Our Reference: 213132

RE: SSD- 46983729 Westlink Industrial Estate Stage 2 at 1030-1048 & 1050-1064 Mamre Road, 59-62 & 63 Abbots Road and 290-308 Aldington Road, Kemps Creek

Sydney Water requests additional information and further clarification regarding stormwater matters to progress the referral. DPHI is advised to re-refer this SSDA for Sydney Water's review once stormwater issues have been addressed.

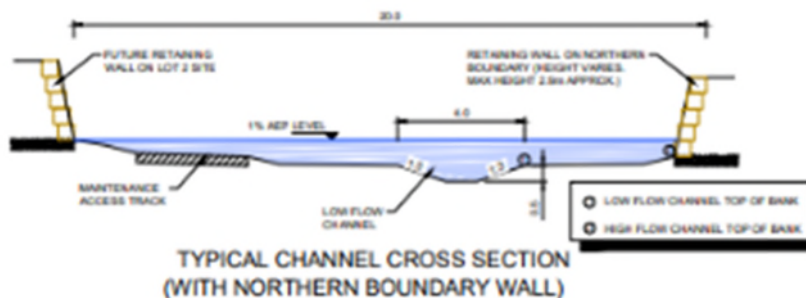
1. The SW in principle letter of agreement references the realignment of the channel but makes no mention of a reduction in channel width from 25m as shown in the Stormwater Scheme Plan.
2. The channel as shown in the sketch below will have flows impacting the base of the retaining walls. This is considered a potential point of failure and should be designed to align with the Design Guidelines - "This system will have sufficient capacity to capture and convey flows up to or exceeding the 1% AEP"

3. "the peak 1% AEP are at a maximum of 7.4m³/s at the Mamre Road end". According to the design guideline, the channel should therefore be 25m wide.
 - a. 20m corridor 2 – 4.5 m³/s
 - b. 25m corridor 4 – 11 m³/s
 - c. 30m corridor 11 – 20 m³/s
4. Review statement in Attachment B section 29

- a. Catchment boundaries to be provided overlaying existing natural catchments with design catchments in shape or CAD files to understand the gap with SW evaluation.
- b. Modelling parameters to be aligned with Design guidelines.
- c. Retaining wall at the border of the property (north) should be replaced with a batter (1 in 4) to avoid impacting the neighbouring lot.
- d. Demonstrate that low flow invert channel conveys 12 EY.
- e. Demonstrate water level at PMF, 5% AEP and 20% AEP
- f. Provide retaining wall longsection on channel longsection to show wall to invert and maintenance track relationship.
- g. Please provide the dimensioning of the different elements of the trunk drainage: access road, riparian edge, upper bank and lower bank.

3. Plot PMF level against the retaining wall.
4. Retaining walls need to be certified by structural engineer: stability and resilience to flooding up to the PMF need to be engineered.
5. Sydney Water will NOT own and maintain the retaining wall along the trunk drainage channel that is adjacent and supporting the development site and the neighbouring lot. As such should be clear of the 1% AEP trunk flows.
6. At the downstream end of the channel the retaining wall is also blocking flows from undeveloped property to the north. This shall be designed to ensure there is no adverse stormwater flow impact to this property.
